November 3, 2016

05097 Version 2

Creak From the B-pillar

(Supersedes 16-035, Dated July 23, 2016, to revise the information highlighted in yellow)

REPAIR PROCEDURE A

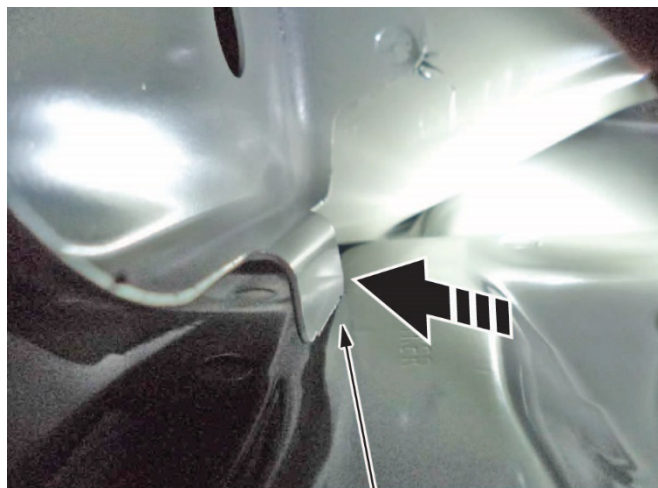
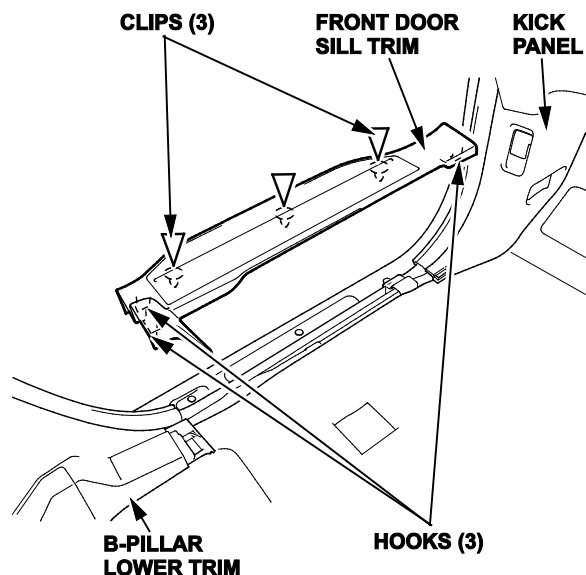
REVISION SUMMARY**REPAIR PROCEDURE A has been added.****SYMPTOM**

1. Use a screwdriver to bend the tab away from the outer side panel.

2. After bending the bulkhead tab, test-drive the vehicle to confirm the noise has been eliminated.
 - If the noise is gone, no further action is needed.
 - If the noise is still present, go to **REPAIR PROCEDURE B**.
